## SERVICE BULLETIN MAINTENANCE OF WAY EQUIPMENT

**BULLETIN NO:** 17-011

**TITLE:** Grinding Head Accumulator Pre-Charge Pressure Settings

**PRODUCT SERIES / MODEL:** RSP16A1-26, RGE16A1-01 and RGE16A1-02

FIGURE 1  
CHECKING AND CHARGING ACCUMULATORS

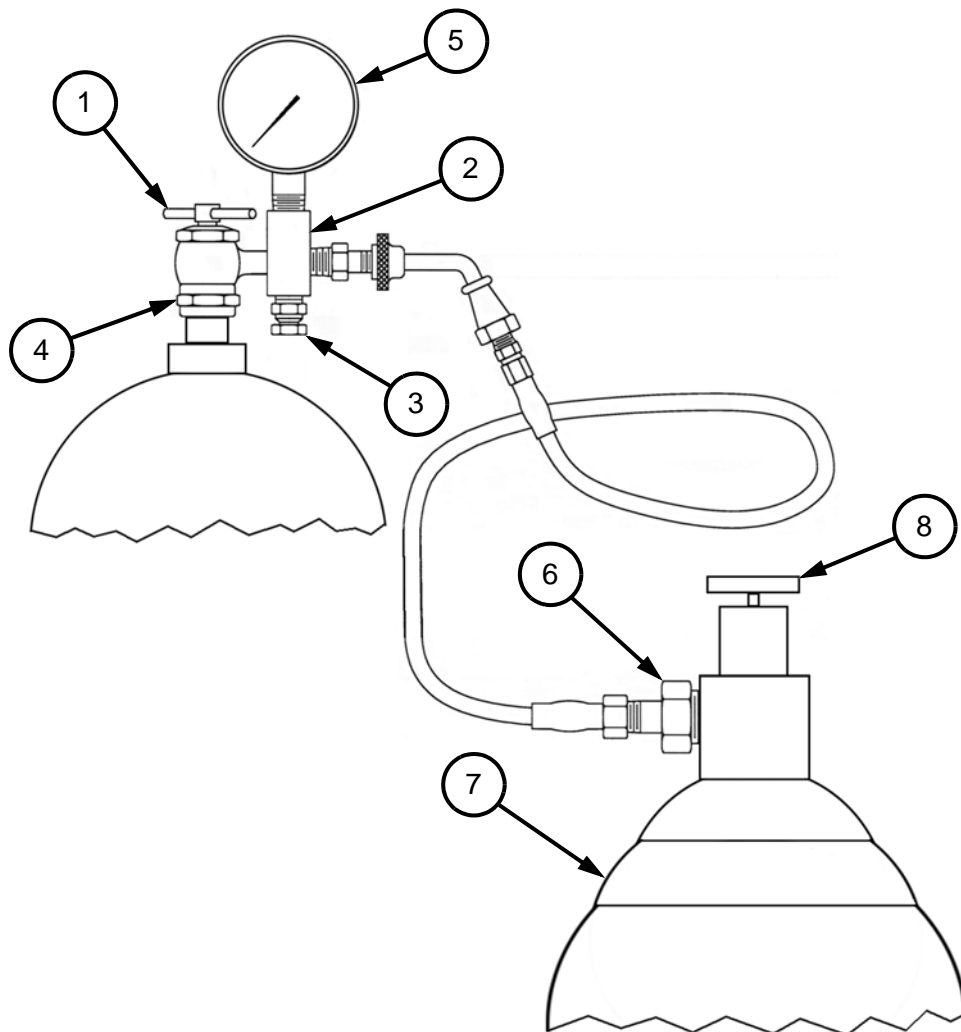
### Checking And Charging Accumulators - See Figure 1

3. The two accumulators are set at different pre-charge pressures. The pressures are:
  - a. Head Feed Circuit: 1000 ± 5 PSI 69.00 ± 0.34 Bar  
*Note: The feed circuit is the circuit with the compensator set at 1500 psi. See the hydraulic schematic.*

- b. Head Retract Circuit: 300 ± 2 PSI 20.68 ± .14 Bar  
*Note: The retract circuit is the circuit with the compensator set at 375 psi. See the hydraulic schematic.*

5. Remove gas valve guard and gas valve cap from the accumulator.
6. Rotate the gas chuck "T" Handle (1) counter-clockwise all of the way out before attaching charging assembly (2) to the accumulator gas valve.

7. Make sure the bleed valve (3) on the charging assembly is closed.
8. Attach swivel nut (4) to the gas valve and tighten to 1.13 - 1.69 N-m (10-15 lb-in).

9. Turn gas chuck "T" Handle (1) until the gauge (5) starts showing the pressure in the accumulator. Do not turn the "T" Handle all the way down, as it will damage the valve core.

11. When charging the accumulator, use only nitrogen that is free of any contaminates. Connect charging hose end (6) to the nitrogen bottle (7).

12. Crack open nitrogen bottle valve (8) and slowly add nitrogen to the accumulator. Close the valve when gauge indicates desired charge. Let the charge set for 10 to 15 minutes. This will allow the gas temperature to stabilize.
13. If the desired charge is exceeded, close nitrogen bottle valve, then slowly open bleed valve (3). Do not reduce charge by depressing valve core with a foreign object. High pressure may rupture rubber valve seat.
14. When finished checking or charging the accumulator, turn "T" Handle (1) all the way out and then open bleed valve (3).
15. Remove charging hose from nitrogen bottle. Remove charging assembly (2) from the accumulator.
16. Check for charge leak at the valve core using a common leak reactant.
17. Replace gas valve cap and tighten to 1.13 - 1.69 N-m (10-15 lb-in). Gas valve cap serves as a secondary seal. Replace accumulator gas valve guard cap.
